CITY OF CHARLOTTESVILLE
DEPARTMENT OF NEIGHBORHOOD DEVELOPMENT SERVICES
STAFF REPORT

COMPREHENSIVE PLAN COMPLIANCE REVIEW

APPLICATION NUMBER: CP23-00001: 0 E High Street

Date of Staff Report: July 31, 2023

Proposed Public Road A—Preliminary Site Plan dated June 2, 2023

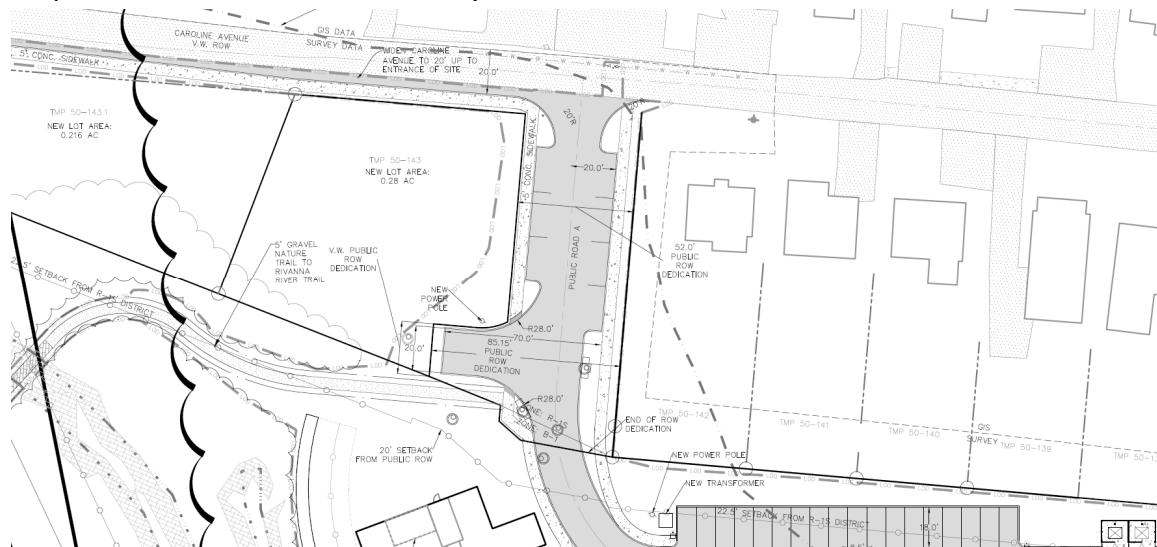
Staff Analysis: Per Section 34-28(c), public facilities may be deemed a feature already shown on the adopted comprehensive plan, provided that the city council has by ordinance or resolution defined standards governing the construction, establishment or authorization of such public facility. City Council defined standards through the adoption of the [Standards and Design Manual](#) (SADM) on December 2, 2019. The City Traffic Engineer has confirmed proposed Public

Road A, as presented, is consistent with the requirements of the SADM. The City Traffic Engineer find the roadway serves a public good by incorporating access and parking for the city trail network.

Per Section 34-241(a), the floodplain ordinance applies to both privately and publicly owned land within the Special Flood Hazard Area (SFHA) developed by the Federal Emergency Management Agency (FEMA). Per Section 34-256(b), a floodplain permit is required prior to the approval of a final site plan for the proposed development. Section 34-256(a) states that *under no circumstances shall a permit be issued to authorize any use, activity, and/or development that would adversely affect the capacity of the channels or floodways of any watercourse, drainage ditch, or any other drainage facility or system*. Therefore, the final design of proposed Public Road A must comply with the floodplain ordinance and demonstrate no adverse effect in order to receive approval.

Several goals of the 2021 Comprehensive Plan and 2022 Urban Rivanna River Corridor Plan (an amendment to the comprehensive plan) speak to the importance of improving public access to the Rivanna River, public spaces, and trail networks. However, several goals also underscore the importance of preserving environmental resources such as floodplains, and the importance of a complete street network to improve connectivity and distribute traffic.

The Guiding Principles of the 2016 Streets that Work plan (an amendment to the comprehensive plan) state *Charlottesville will be a multi-modal, connected community...* and the planning of public streets will be a... *collaborative process to ensure decisions made about the city's streets reflect the public's priorities.* Public Road A is considered a *Local Street* per the 2016 Streets that Work Plan. *Local Streets* are characterized as the majority of the street

network and have no specific associated typology due to the variation of context and available space. The Streets that Work Plan notes design elements on Local Streets should not exceed the dimensions specified for *Neighborhood B* streets, and that techniques such as curb extensions are appropriate. A minimum of five (5) to six (6) feet of clear zone width for sidewalks is recommended for *Neighborhood B* streets. Sidewalks and on-street parking are noted as the highest priority street elements. Public Road A provides a five (5) foot sidewalk (without curbside buffer zone), on-street parking, and curb extensions at the intersection with Caroline Avenue. Public Road A will provide additional public access to the Rivanna River trail network but will not provide connectivity to the wider street network and community.

Proposed Public Road – Preliminary Site Plan dated June 2, 2023

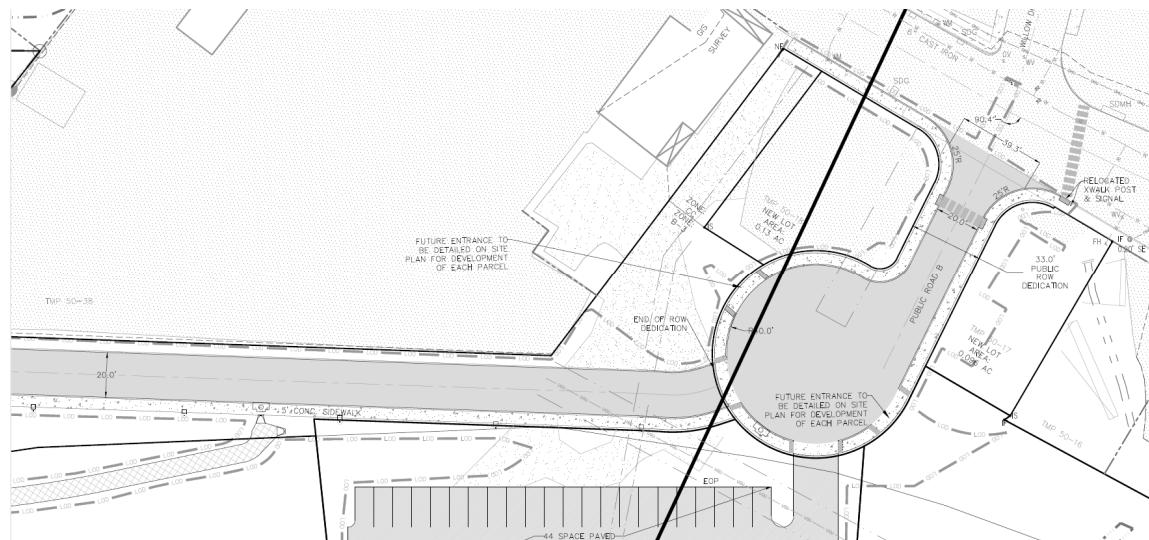
Staff Analysis: Per Section 34-28(c), public facilities may be deemed a feature already shown on the adopted comprehensive plan, provided that the city council has by ordinance or resolution defined standards governing the construction, establishment or authorization of such public facility. City Council defined standards through the adoption of the [Standards and Design Manual](#) (SADM) on December 2, 2019. The City Traffic Engineer has confirmed proposed Public Road B, as presented, is consistent with the requirements of the SADM. The City Traffic Engineer find the roadway has a proper turn around, matches the intersection on the opposite

side of the street, and has the proper sidewalks. The roadway also serves a public good by incorporating access and parking for the city trail network.

Per Section 34-241(a), the floodplain ordinance applies to both privately and publicly owned land within the Special Flood Hazard Area (SFHA) developed by the Federal Emergency Management Agency (FEMA). Per Section 34-256(b), a floodplain permit is required prior to the approval of a final site plan for the proposed development. Section 34-256(a) states that *under no circumstances shall a permit be issued to authorize any use, activity, and/or development that would adversely affect the capacity of the channels or floodways of any watercourse, drainage ditch, or any other drainage facility or system*. Therefore, the final design of proposed Public Road B must comply with the floodplain ordinance and demonstrate no adverse effect in order to receive approval.

Several goals of the 2021 Comprehensive Plan and 2022 Urban Rivanna River Corridor Plan (an amendment to the comprehensive plan) speak to the importance of improving public access to the Rivanna River and trail networks. However, several goals also underscore the importance of preserving environmental resources such as floodplains, and the importance of a complete street network to improve connectivity and distribute traffic.

The Guiding Principles of the 2016 Streets that Work plan (an amendment to the comprehensive plan) state *Charlottesville will be a multi-modal, connected community...* and the planning of public streets will be a... *collaborative process to ensure decisions made about the city's streets reflect the public's priorities.* Public Road B is considered a *Local Street* per the 2016 Streets that Work Plan. *Local Streets* are characterized as the majority of the street network and have no specific associated typology due to the variation of context and available space. The Streets that Work Plan notes design elements on Local Streets should not exceed the dimensions specified for *Neighborhood B* streets, and that techniques such as curb extensions are appropriate. A minimum of five (5) to six (6) feet of clear zone width for sidewalks is recommended for *Neighborhood B* streets. Sidewalks and on-street parking are noted as the highest priority street elements. Public Road B provides a five (5) foot sidewalk

(without curbside buffer zone) and access to proposed Lot B, which provides a trail connection to the Rivanna River trail network. Public Road B will provide additional public access to the Rivanna River trail network contingent on the establishment of the proposed trail network connecting through Lot B but will not provide connectivity to the wider street network and community.

Proposed Widening and Improvements– Preliminary Site Plan dated June 2, 2023

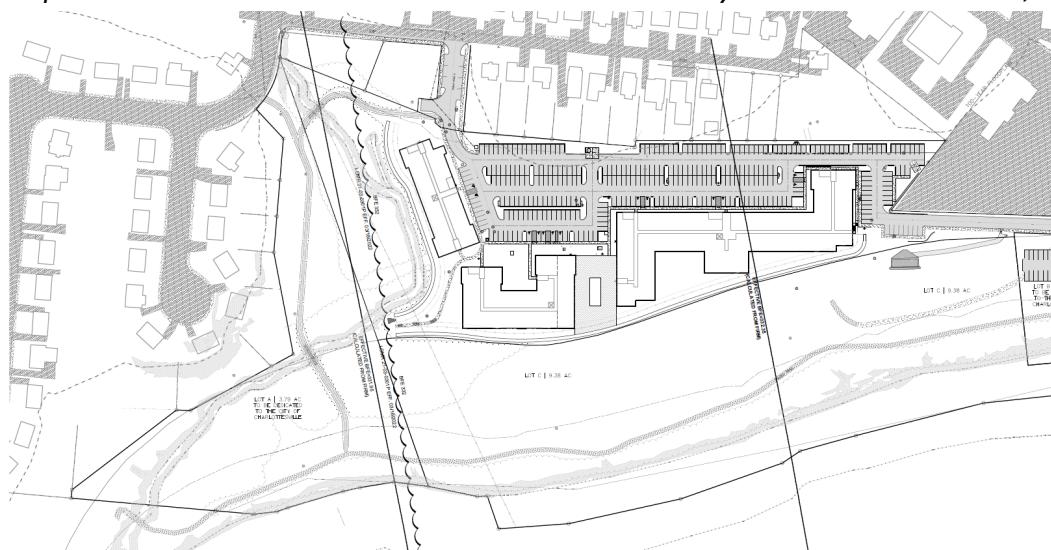
Staff Analysis: Per Section 34-28(c), public facilities may be deemed a feature already shown on the adopted comprehensive plan, provided that the city council has by ordinance or resolution defined standards governing the construction, establishment or authorization of such public facility. City Council defined standards through the adoption of the [Standards and Design Manual](#) (SADM) on December 2, 2019. The City Traffic Engineer has confirmed proposed improvements to Caroline Avenue and Fairway Avenue, as presented, are consistent with the requirements of the SADM. The City Traffic Engineer finds that by widening the roadway, the project meets the minimum criteria for allowing the “Road A” connection and providing a safe access point from the development to a city street.

Per Section 34-241(a), the floodplain ordinance applies to both privately and publicly owned land within the Special Flood Hazard Area (SFHA) developed by the Federal Emergency Management Agency (FEMA). Per Section 34-256(b), a floodplain permit is required prior to the approval of a final site plan for the proposed development. Section 34-256(a) states that *under no circumstances shall a permit be issued to authorize any use, activity, and/or development that would adversely affect the capacity of the channels or floodways of any watercourse, drainage ditch, or any other drainage facility or system.* Therefore, the final design of the widening of Caroline Avenue and Fairway Avenue must comply with the floodplain ordinance and demonstrate no adverse effect in order to receive approval.

Several goals of the 2021 Comprehensive Plan and 2022 Urban Rivanna River Corridor Plan (an amendment to the comprehensive plan) speak to the importance of improving public access to the Rivanna River and trail networks as well as transit stops. The widening of Caroline Avenue and Fairway Avenue will permit a new public sidewalk connection on Caroline Avenue, which will connect pedestrians to both proposed Public Road A and Lot A, as well as the existing transit stop on Fairway Avenue and nearby Meade Park. However, the widening will not address the lack of sidewalks on the remainder of Caroline Avenue.

Proposed Lot Dedication and Trail Network – Preliminary Site Plan dated June 2, 2023

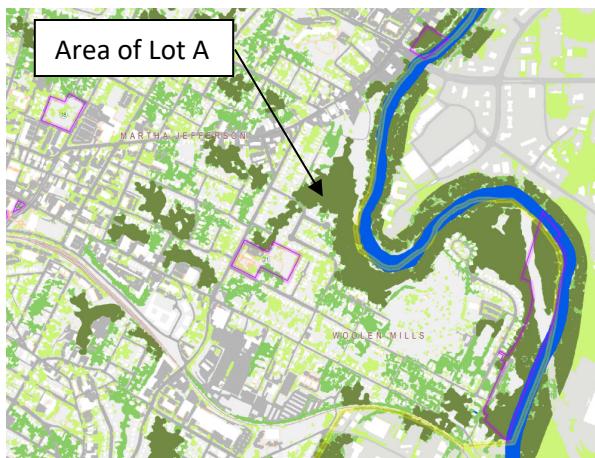
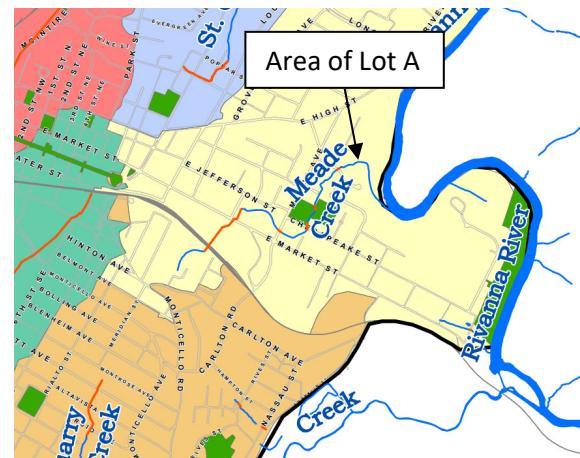
Staff Analysis: Per Section 34-241(a), the floodplain ordinance applies to both privately and publicly owned land within the Special Flood Hazard Area (SFHA) developed by the Federal Emergency Management Agency (FEMA). Per Section 34-256(b), a floodplain permit is required prior to the approval of a final site plan for the proposed development. Section 34-256(a) states that *under no circumstances shall a permit be issued to authorize any use, activity, and/or development that would adversely affect the capacity of the channels or floodways of any watercourse, drainage ditch, or any other drainage facility or system*. Therefore, the final design of the proposed trail must comply with the floodplain ordinance and demonstrate no adverse effect in order to receive approval.

Several goals of the 2021 Comprehensive Plan and 2022 Urban Rivanna River Corridor Plan (an amendment to the comprehensive plan) speak to importance of protecting tree canopy and habitats, particularly in areas within the Rivanna River corridor and near local waterways. The 2020 City GreenPrint 1.0 plan (an appendix of the comprehensive plan) identifies the forested area of Lot A as part of a larger tree canopy patch, and notes such patches can provide wildlife habitat, infiltration of stormwater, and other ecological benefits beyond those provided by individual tree plantings. Donation of Lot A will allow the City to preserve and protect the environmental resources on the lot.

Several goals of the 2021 Comprehensive Plan and 2022 Urban Rivanna River Corridor Plan speak to importance of increasing public access to the Rivanna River and trail network. The 2015 Bicycle and Pedestrian Master Plan (an amendment to the comprehensive plan) recommends a new shared use path connection in the area of Lot A between the Rivanna River Trail and Fairway Avenue. Therefore, the trail network proposed on Lot A will provide an additional connection to the Rivanna River in a priority location.

Proposed Lot Dedication, Public Parking Lot, and Trail Network – Preliminary Site Plan dated June 2, 2023

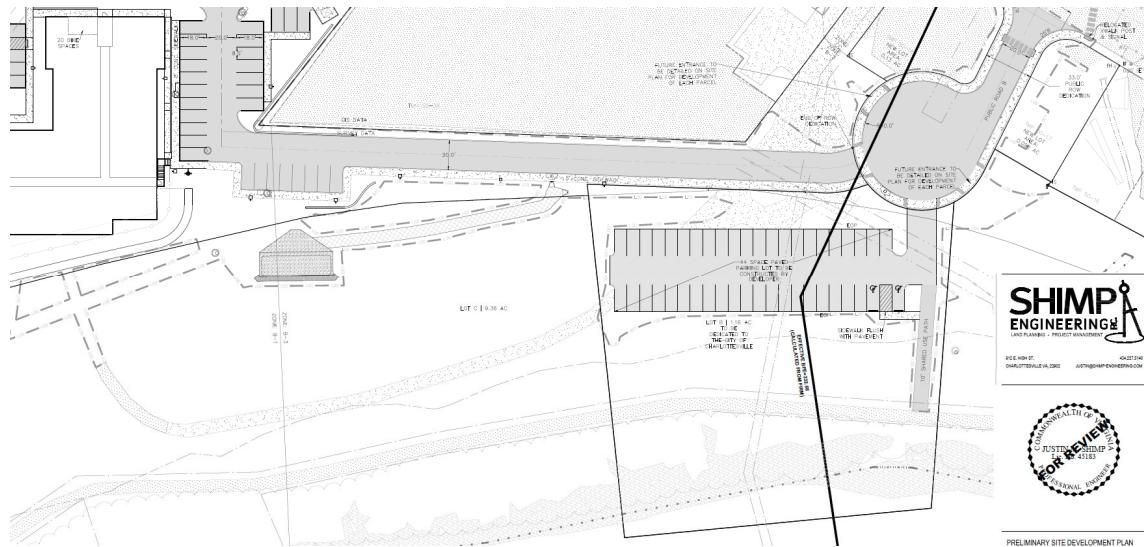
Staff Analysis: Per Section 34-241(a), the floodplain ordinance applies to both privately and publicly owned land within the Special Flood Hazard Area (SFHA) developed by the Federal Emergency Management Agency (FEMA). Per Section 34-256(b), a floodplain permit is required prior to the approval of a final site plan for the proposed development. Section 34-256(a) states that *under no circumstances shall a permit be issued to authorize any use, activity, and/or development that would adversely affect the capacity of the channels or floodways of any watercourse, drainage ditch, or any other drainage facility or system*. Therefore, the final design of the proposed parking lot and trail must comply with the floodplain ordinance and demonstrate no adverse effect in order to receive approval.

Several goals of the 2021 Comprehensive Plan and 2022 Urban Rivanna River Corridor Plan speak to importance of increasing public access to the Rivanna River and trail network. Riverview Park, located approximately one (1) mile south as measured along the Rivanna Trail, is the nearest public parking facility providing access to the Rivanna Trail. The high utilization rate of parking at Riverview Park indicates additional public parking facilities would improve community access to the Rivanna Trail. Therefore, the proposed public trail parking and associated trail connection to the Rivanna Trail will provide an additional connection to the Rivanna River in a priority location.
